**New Castle, Colorado
Planning and Zoning Commission
Wednesday, March 25, 2026, 7:00 PM**

Consider Resolution No. PZ 2026-3 A RESOLUTION OF THE NEW CASTLE PLANNING AND ZONING COMMISSION RECOMMENDING APPROVAL OF A CONDITIONAL USE PERMIT FOR AN ELECTRICAL SUBSTATION IN THE INDUSTRIAL ZONE DISTRICT

**Planning Commission – Public Hearing
Wednesday, March 25, 2026
Resolution PZ 2026-3
Staff Report**

COAL RIDGE SUBSTATION

f. Points of ingress and egress;

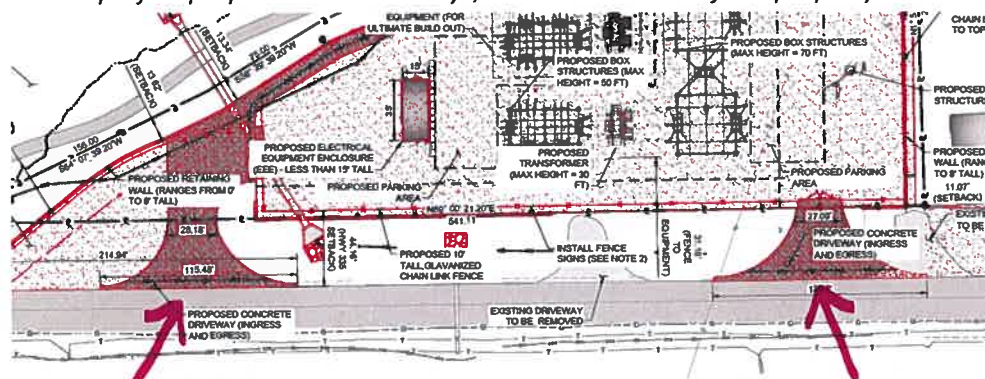
The project proposes two driveways, one at either end of the property.

h. Signs and exterior lighting;

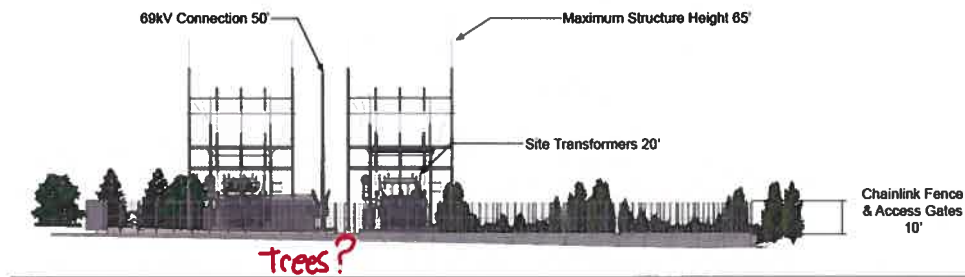
Exterior lighting is currently proposed as flood lighting. As a condition of approval, all exterior lighting shall conform to dark-sky standards and shall always be shut off other than for emergencies or maintenance. Otherwise, exterior lighting shall comply with section C405.2.7 of the energy code. C405.2.7 includes provisions for sensors, timers, and lighting reduction as necessary.

Mr. Miller said he would add notes about lights only on during emergency work during nighttime hours so the substation would be dark sky compliant. Mr. Miller said light shields would be added to the lights in the plan. Planner Smith said there was a condition in the resolution that a right-of-way would be included in that.

COAL RIDGE SUBSTATION LANDSCAPE PLAN

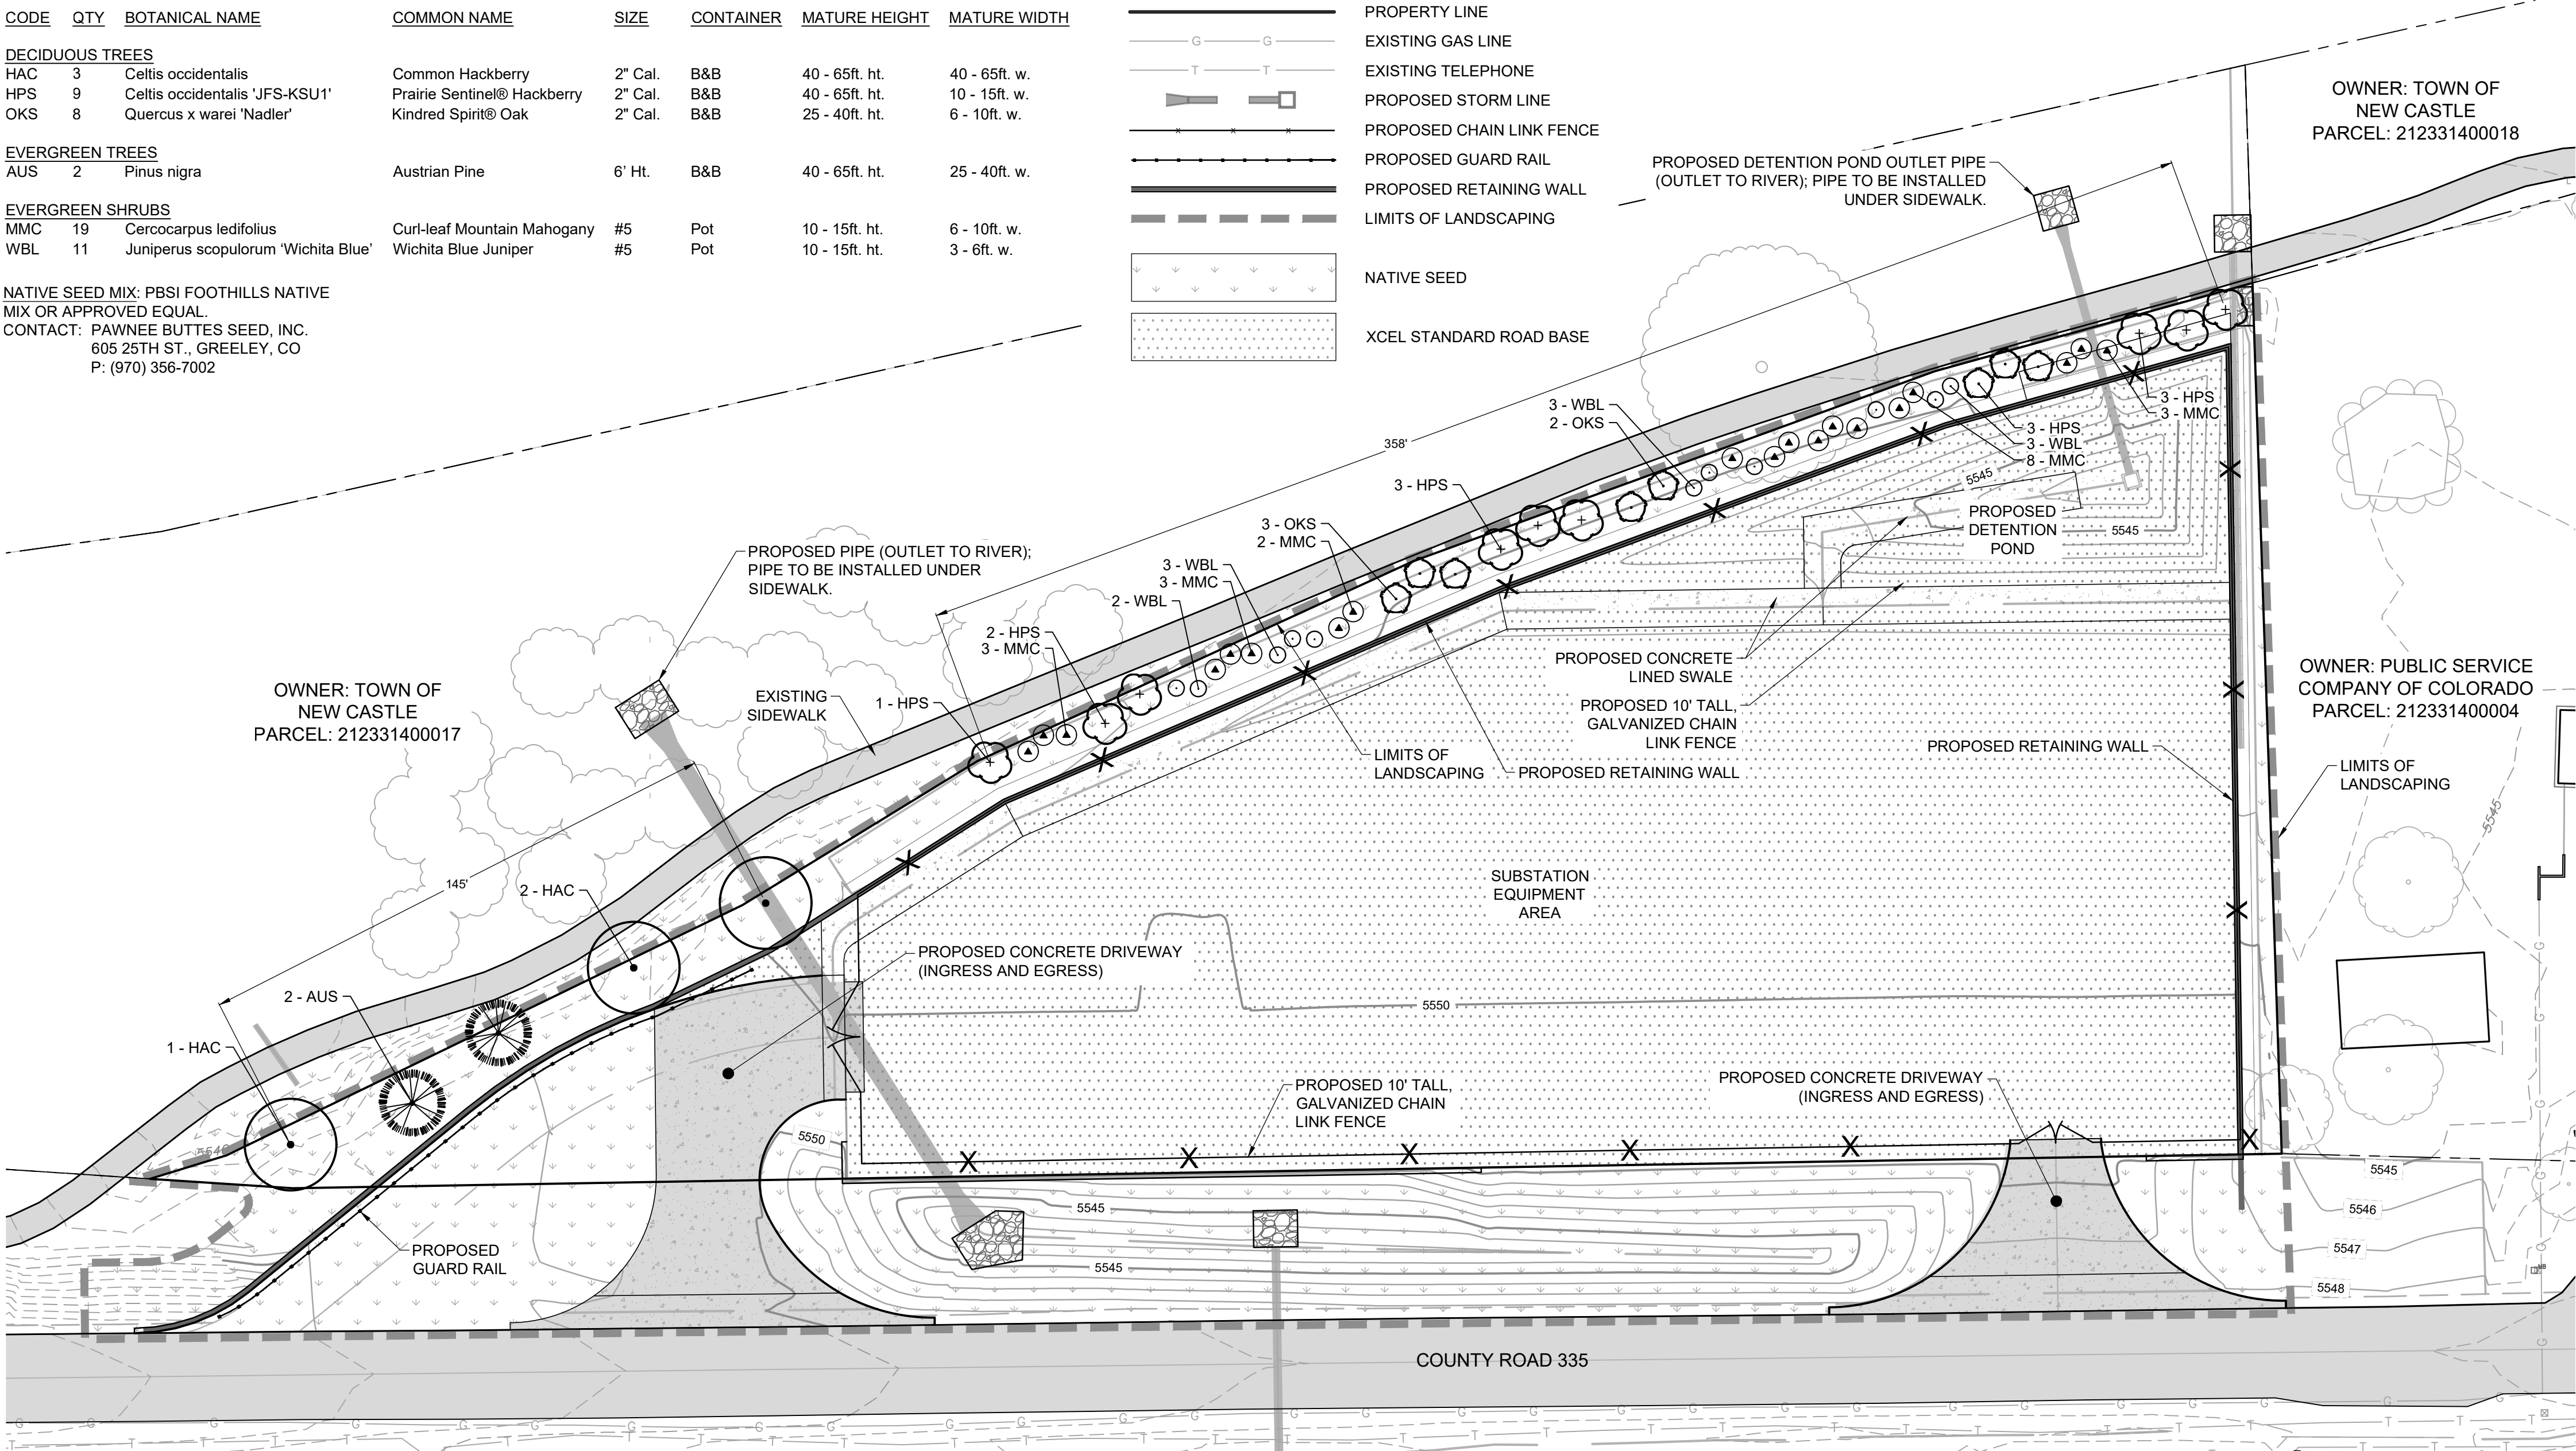
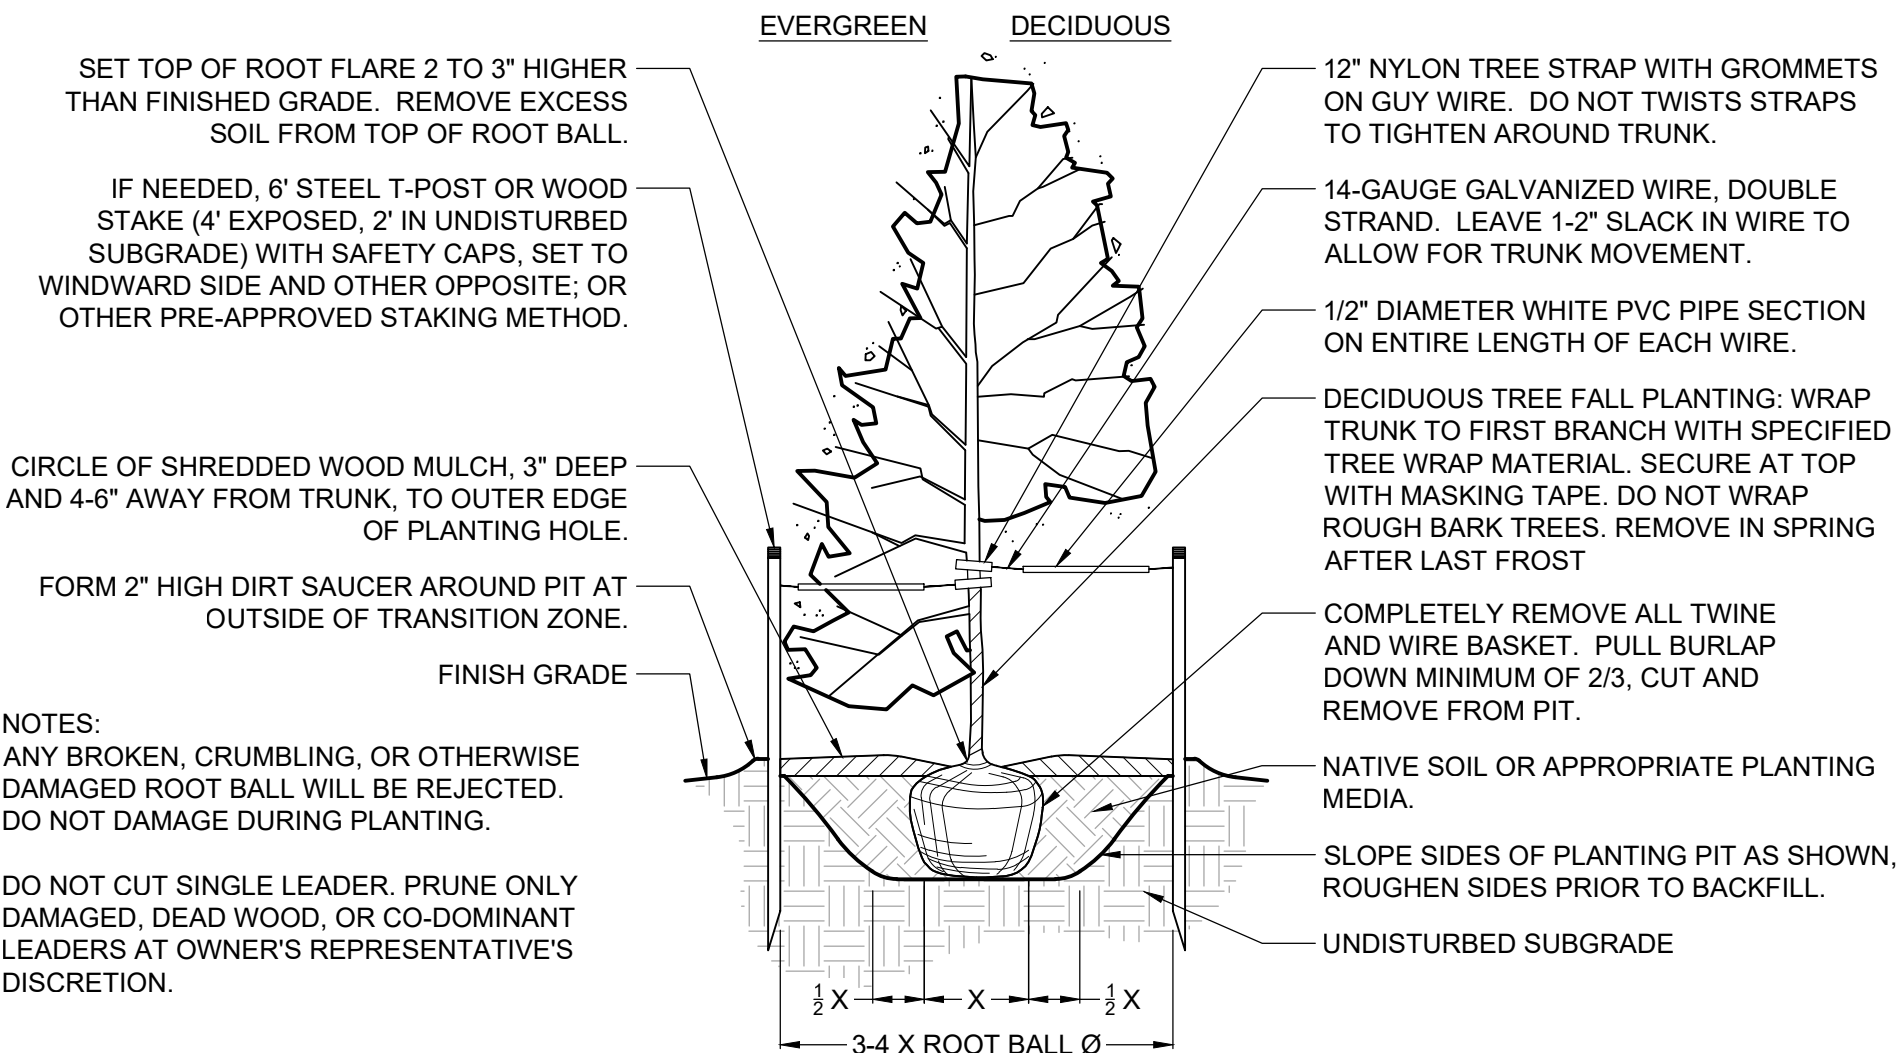
Castle's downtown area. Additional screening may be necessary on the west aspect to comply with "25%" code requirement.

Mr. Miller reviewed the landscaping plan. **(Exhibit C)** Administrator Reynolds asked if the applicants considered landscaping the south property line along County Road 335. Mr. Miller said the main landscaping concern was the northern property line along the bike path and they did not intend to install landscaping on the south side.

Administrator Reynolds said landscaping would help break up the mass of the wall and

fence. Mr. Miller said the applicants were aware there was a use on that side of the wall and understood it was outdoor storage facility. Mr. Miller said he was not sure if there was a privacy need when the application was originally considered. Chair Apostolik said the south side of the property is lower than the road, even after the applicants construct the grade higher than the floodplain. Chair Apostolik said P & Z had that discussion with a previous applicant. Commissioner McDonald said it would be nicer to have landscaping on that south wall. Planner Smith said to discuss with the applicants.

5. The Applicant shall apply for any right-of-way permits through the Town's Public Works Department.
6. Applicant shall add vegetative screening along the west property line pursuant to section 17.52.060. The approved constructions drawings shall demonstrate conformance with the landscaping,

screening, retaining wall, and berm designs provided in the application.
